Code Administrator Consultation		
<h1>GC0151:</h1> <h2>Grid Code Compliance with Fault Ride Through Requirements</h2> <p>Overview: A letter issued by the ESO on 7th May 2021 and a presentation to be made to the 27th May 2021 GCRP have identified concerns about demonstrating compliance with the Fault Ride Through Requirements in the Grid Code. This proposal seeks to apply a workable, non-discriminatory, legally compliant solution based on Good Industry Practice to address this significant operational concern in an expedited manner.</p>	<h3>Modification process & timetable</h3>	
	1	Proposal Form 23 June 2021
	2	Workgroup Consultation 30 July 2021 – 16 August 2021
	3	Workgroup Report 01 September 2021
	4	Code Administrator Consultation 13 September 2021 – 27 September 2021
	5	Draft Modification Report 07 October 2021
	6	Final Modification Report 11 October 2021
	7	Implementation One working day after Authority Decision

A letter issued by the ESO on 7th May 2021 to stakeholders and a presentation made to the 27th May 2021 Grid Code Review Panel (GCRP) have identified concerns about demonstrating compliance with the Fault Ride Through Requirements in the Grid Code.

Figure 1 showing a theoretical worst case fault which plant has to be capable of riding through.

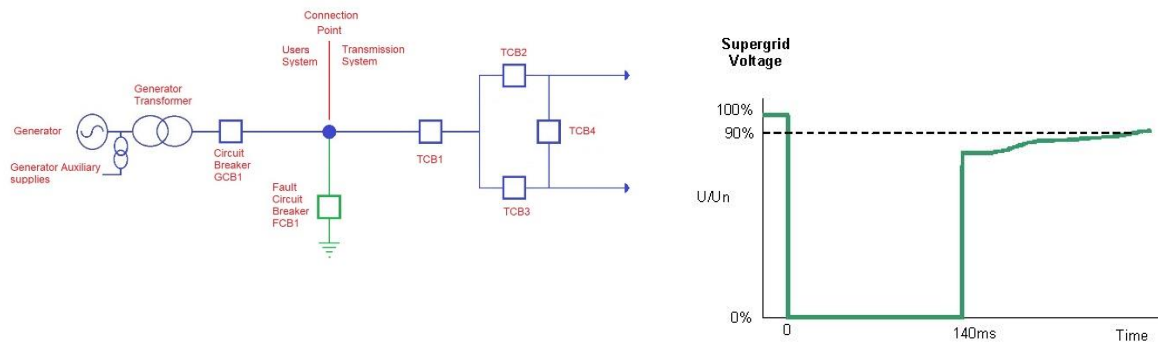
The new section CC.6.3.15(a)(i)(a) would only deal with plant capabilities by clarifying that it has to be capable of riding through the worst fault that the network could impose on the plant which is a 3-phase short circuit at the connection point which lasts for 140ms as shown in figure 1 below. To achieve this the words “be design to” will be added to section CC.6.3.15(a)(i)(a) as can be seen in the legal text contained in WAGCM2 and can be found in Annex 12.

Figure 2 showing a fault which can be cleared by transmission system breakers TCB3 & 4

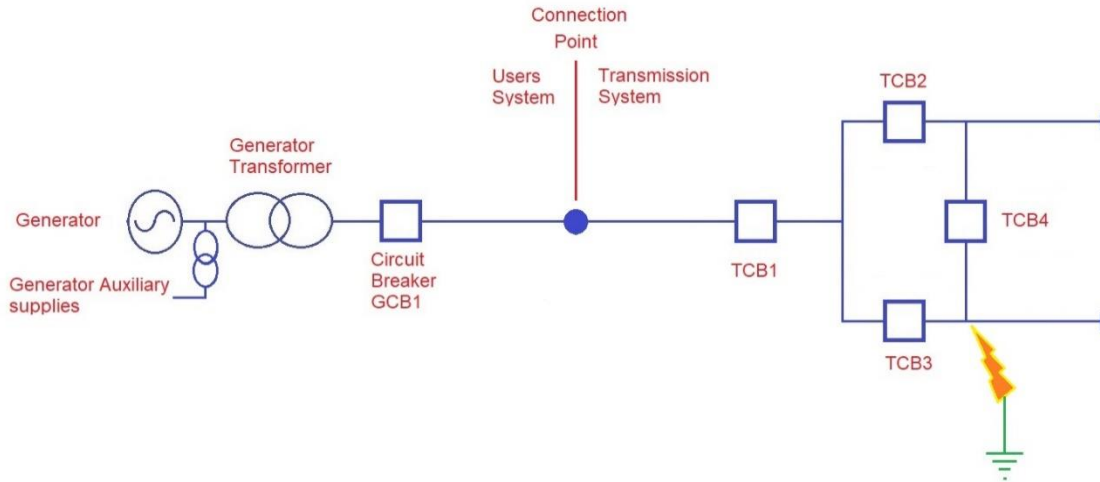
The new section CC.6.3.15(a)(i)(b) should deal with the actions to be taken in the event that a fault occurs firstly by requiring that plants ride through faults on the transmission system which can be cleared by transmission system circuit breaker as shown in Figure 2 below and by adding the following text as the introduction to the section:

- (b) Each **Generating Unit, DC Converter, or Power Park Module** and any constituent **Power Park Unit** thereof and **OTSDUW Plant and Apparatus** shall remain transiently stable and connected to the **System** without tripping of any **Generating Unit, DC Converter or Power Park Module** and / or any constituent **Power Park Unit, OTSDUW Plant and Apparatus**, and for **Plant and Apparatus** installed on or after 1 December 2017, reactive compensation equipment, for any balanced and unbalanced fault where subjected to a voltage dip at the **Connection Point** where the voltage remains either on or within the envelope shown in figure CC.6.3.15(a)(i)(a) except where:

Figure 3 showing a fault which can only be cleared by Generator breakers GCB1

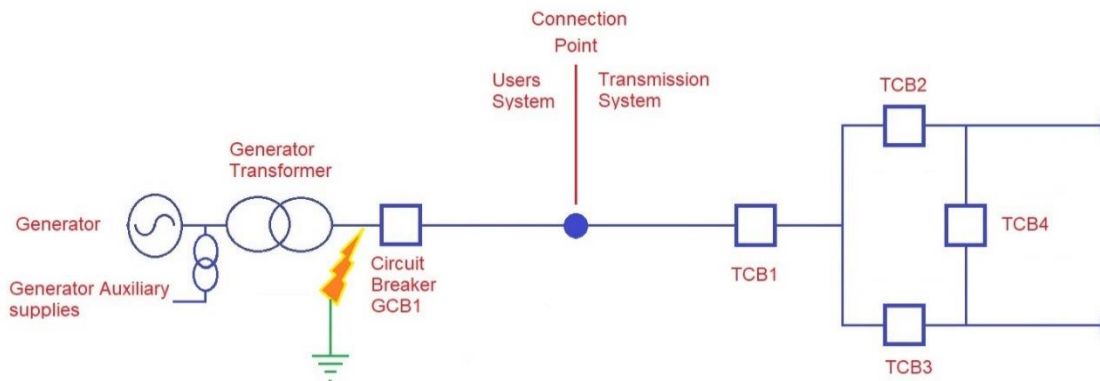
Firstly if the fault is on the Generator's equipment then the Generator shall be required to trip (normally circuit breaker GCB1 in the diagram above) to clear the fault from the transmission system as detailed in the proposed new sections CC.6.3.15(a)(ii)(b)(i) and ECC.6.3.15.8(vi)(i), as follows:-

the fault is on the **User's System**, when the **Generating Unit, DC Converter, or Power Park Module** and any constituent **Power Park Unit** thereof and **OTSDUW Plant and Apparatus** shall trip to clear the fault from the **Transmission System**. The protection schemes and settings should not jeopardise **Fault Ride Through** performance as specified in CC.6.3.15.1

Figure 4 showing a fault which can be cleared by Generator breaker GCB1 & transmission circuit breaker TCB1.

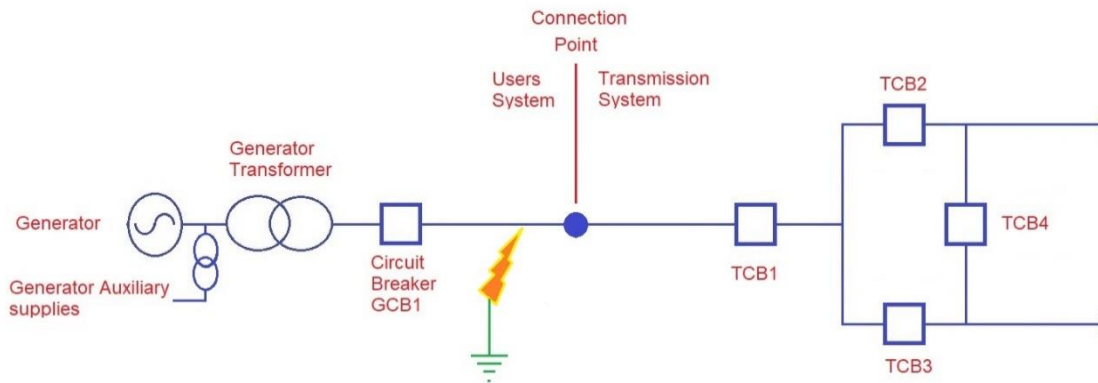
Secondly if the fault is at a location on the network that means that the fault can only be cleared by operation of both transmission and the Generator circuit breakers as shown in Figure 4, again the Generator will be permitted to trip to clear the fault as detailed in the proposed new section CC.6.3.15(a)(i)(b)(ii) and ECC.6.3.15.8(vi)(ii), as follows:-

the location of the fault means it cannot be fully cleared without tripping the of **Generating Unit, DC Converter, or Power Park Module** and any constituent **Power Park Unit** thereof and **OTSDUW Plant** shall trip as required.

Figure 5 showing a fault which can be cleared by transmission breakers TCB1,2&3, however this results in the Generator separated from the main transmission system and needs to be disconnected.

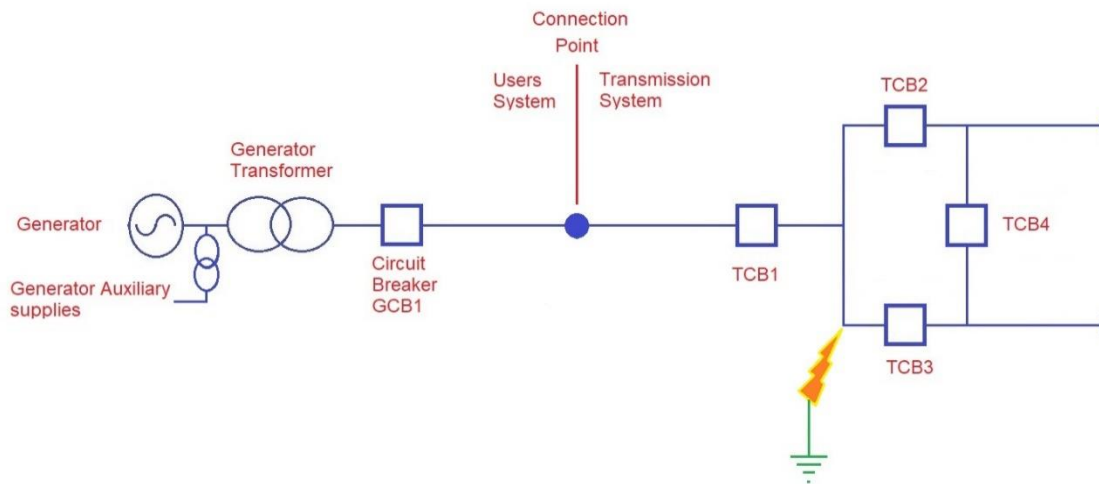
Thirdly if the fault is at a location on the network that means the Generator will become islanded by the operation of the transmission circuit breakers as shown in Figure 5 as detailed in the proposed new sections CC.6.3.15(a)(ii)(b)(iii) and ECC.6.3.15.8(vi)(iii), as follows:-

clearance of the fault results in the **Generating Unit, DC Converter, or Power Park Module** or **OTSDUW Plant** becoming islanded and disconnected from the **Total System** and not supplying **Customers** (where CC.6.3.7(c)(i) applies), then the **Generating Unit, DC Converter, or OTSDUW Plants** shall be permitted to trip as required.

Figure 7 showing the proposed reactive current injection requirements, requiring the current to always remain above the black line

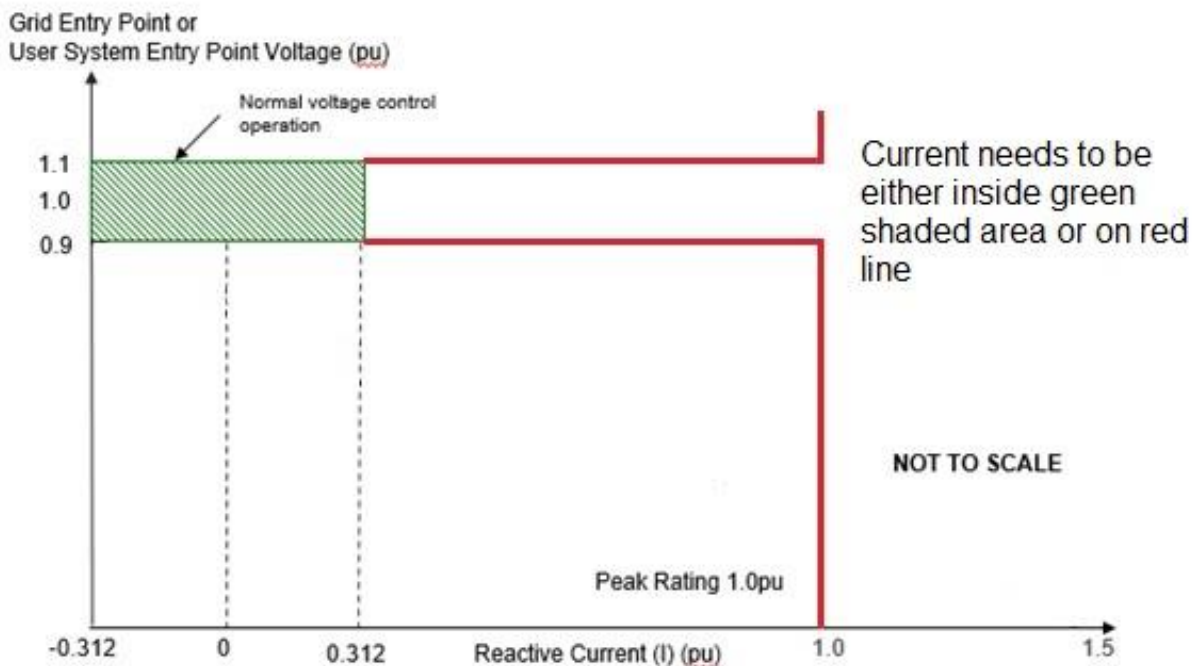
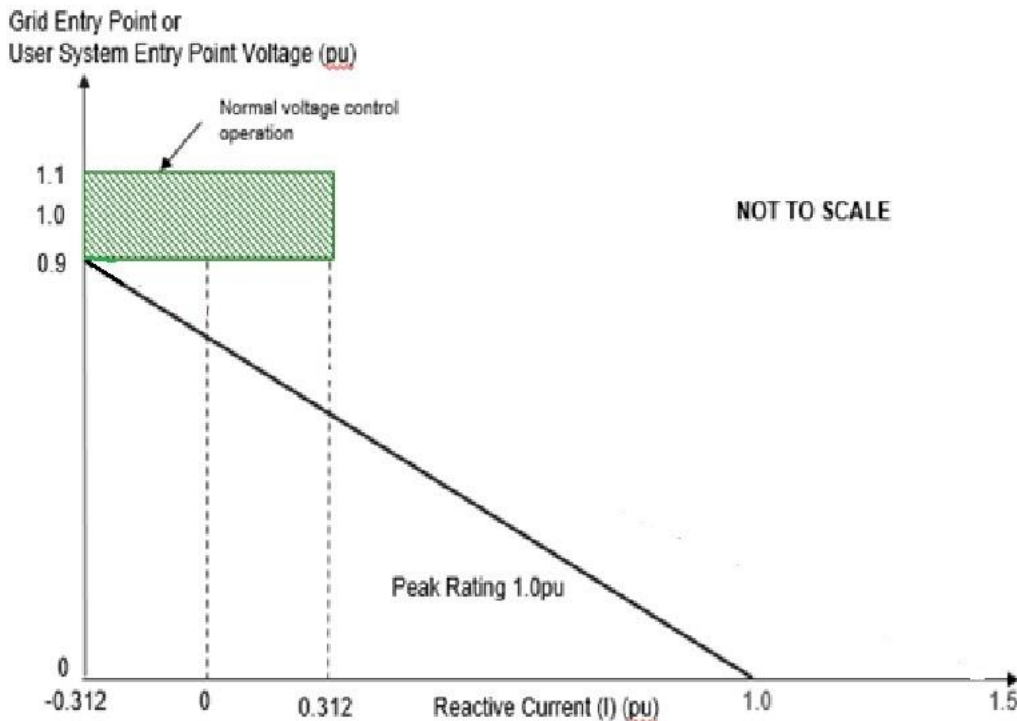
The area of the current (baseline) legal text which technically creates the biggest problem in relation to the ESO's letter of the 7th May 2021 are in sections CC.6.3.15 (a)(ii) and ECC.6.3.15.9.2.1(a)(i) which currently state "for which the voltage at the Grid Entry Point (or Interface Point in the case of OTSDUW Plant and Apparatus) is outside the limits specified in CC.6.1.4, each Generating Unit or Power Park Module or OTSDUW Plant and Apparatus shall generate maximum reactive current". If this requirement is drawn out on the figure 6 below where the reactive current and voltage must always either be within the green shaded area or on the red line.

Figure 6 shows an interpretation of the existing legal text requiring the reactive current to either be in the green box or on the red line, depending on the voltage.

This creates a particular problem in relation to the part of the ESO letter which requires Parties to confirm compliance as the Grid Code particularly FRT sections, because as drafted very few plants (if any) actually do this and this requirement has presumably drifted in as a drafting oversight relating to PPM requirements. This issue has previously been identified in the Workgroup GC0111 on Fast Fault Current injection and in the GC0137 VSM Workgroup and has been fixed for new PPMs, however currently all synchronous Generator and older PPM will technically be non-compliant with this FRT requirement as drafted. This issue was dealt with in GC0111 by adding a new figure as shown in Figure 7 and changing the text as follows.

- (iv) During the period of the fault as detailed in CC.6.3.15.1 (a) (i) for which the voltage at the **Grid Entry Point** (or **Interface Point** in the case of **OTSDUW Plant and Apparatus**) is outside the limits specified in CC.6.1.4, each **Generating Unit** or **Power Park Module** or **OTSDUW Plant and Apparatus** shall inject a reactive current above the heavy black line shown in Figure CC.6.3.15(b), without exceeding the transient rating limit of the **Generating Unit, OTSDUW Plant and Apparatus** or **Power Park Module** and / or any constituent **Power Park Unit** or reactive compensation equipment.

Figure 8 showing a typical active power response of a unit at low load to a fault

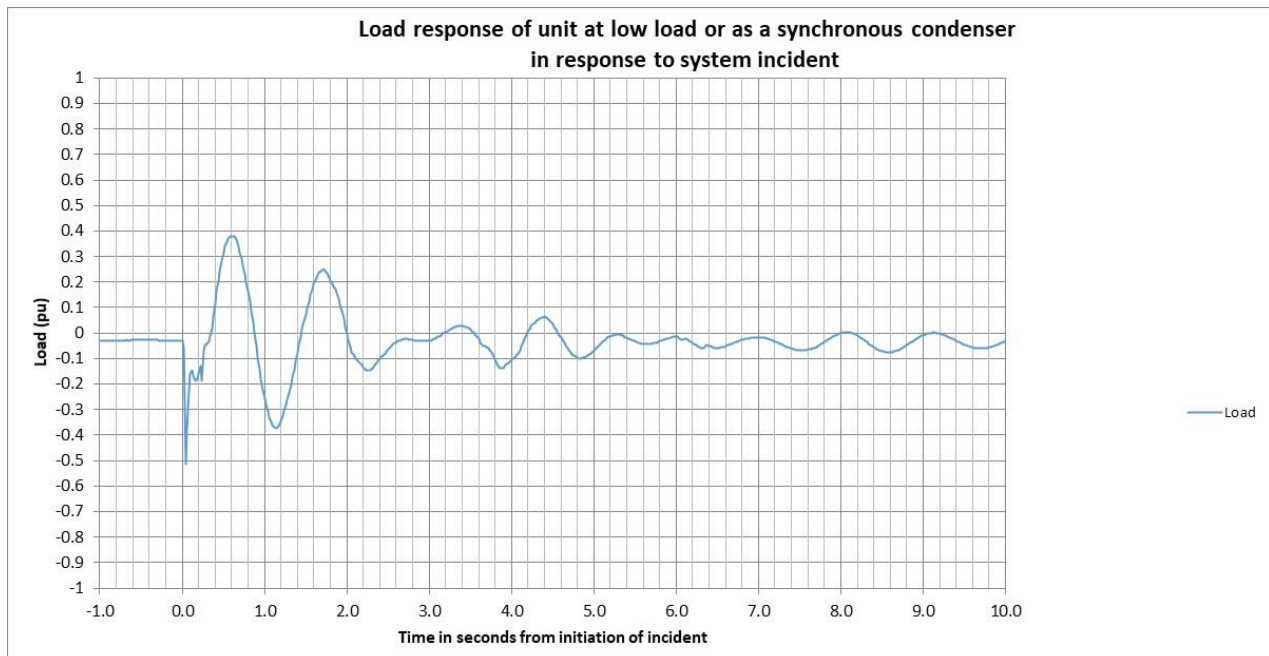
Whilst this works in principle at higher loads, it does create an issue at lower loads if at a real event for a unit operating as a synchronous condenser in figure 8.

When considering that the initial load is 0.02 pu; 90% of this is a very small number. It could be argued that it is difficult to carry out a sensible compliance assessment at these levels and it is hence suggested that the tolerance should be changed to 10% of rated capacity as follows
